Ministry of Public Works

Ref: 41-73-F-200 Retaining Wall Middle Rd Southampton

This Addendum #1 contains (8) pages including this front page.

PART 1 – Clarifications and Revisions

Cable Marking Location Map

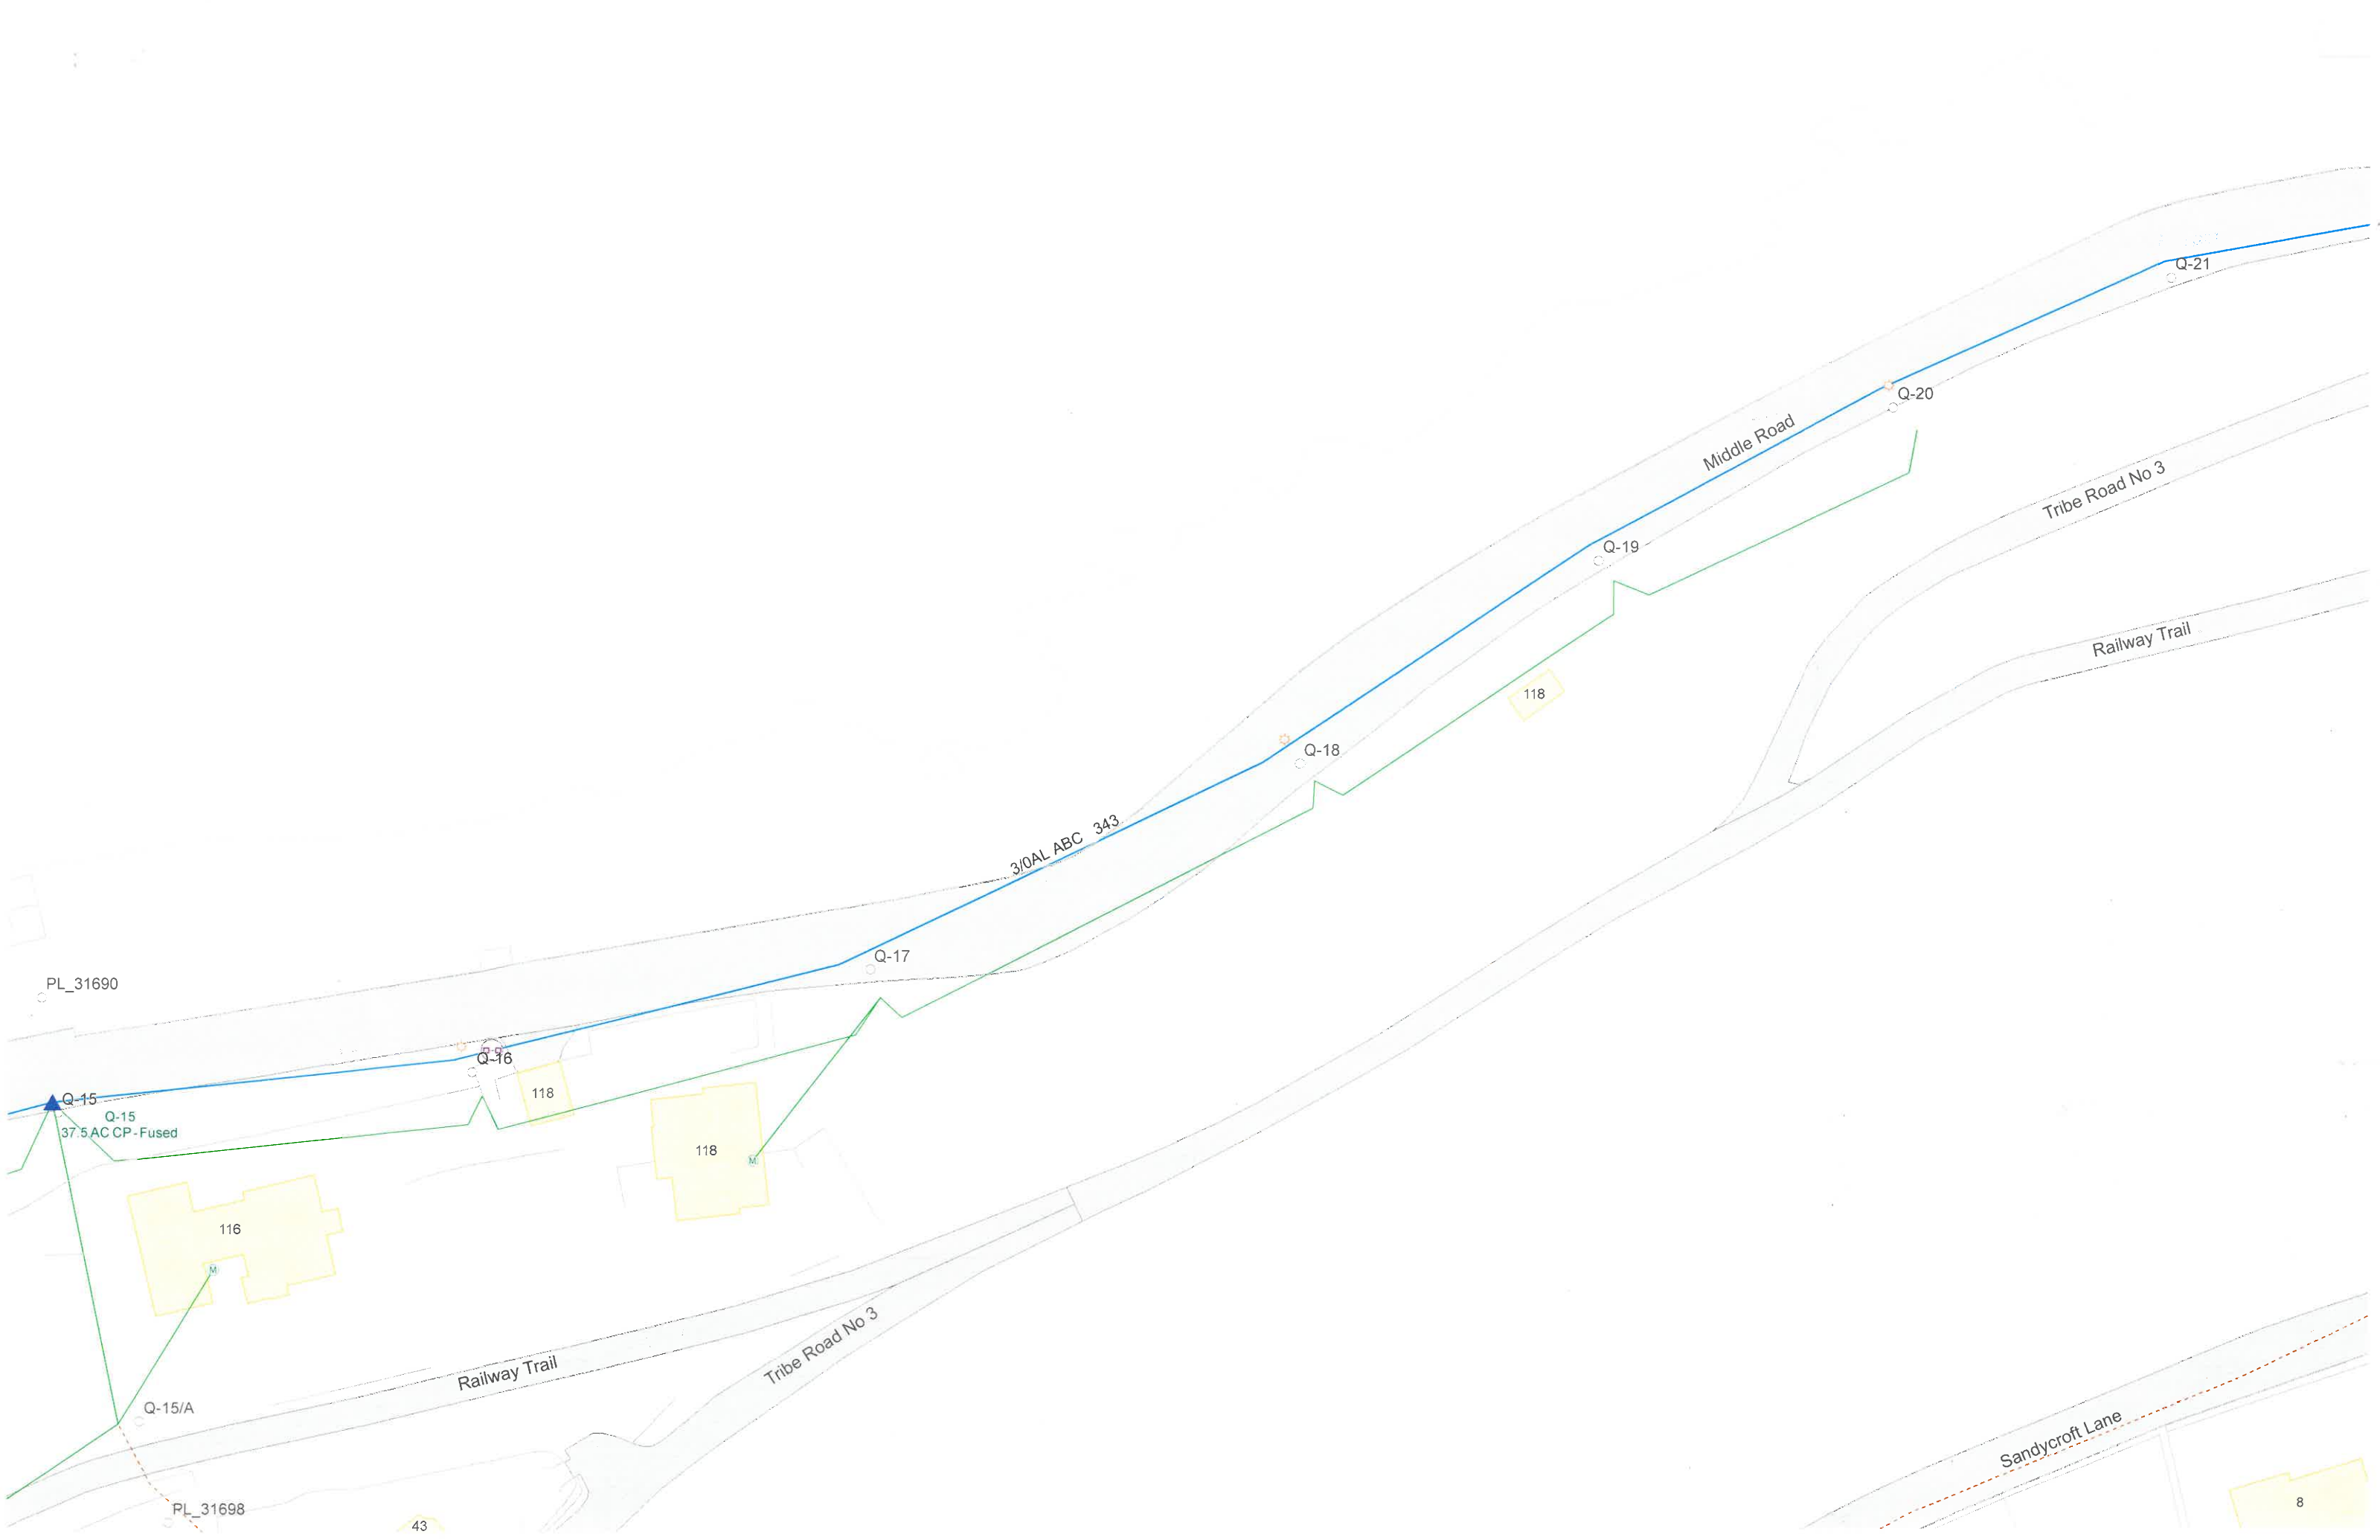
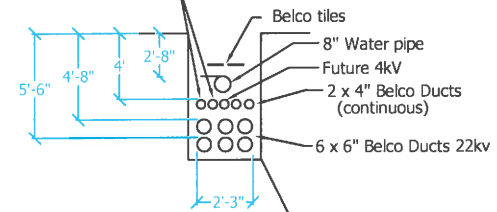
- Details of the services in the trench of the westbound lane have been provided by BELCO. The trench contains 1-8" water main and several electrical conduits. The conduits are empty and there is no live power in the trench. Refer to attached drawings provided by BELCO.
- The methodology of the augered pile installation is left to the contractor. That said, there is a reasonable expectation that the augered hole will require support such as a temporary casing. Mr. Austin Kenny verbally suggested the following methodology:
 - Auger hole, clear sand
 - Sleeve w/ pvc pipe
 - Install rebar cage
 - Tremie concrete
 - Remove PVC sleeve
 - Re-vibrate concrete, top off
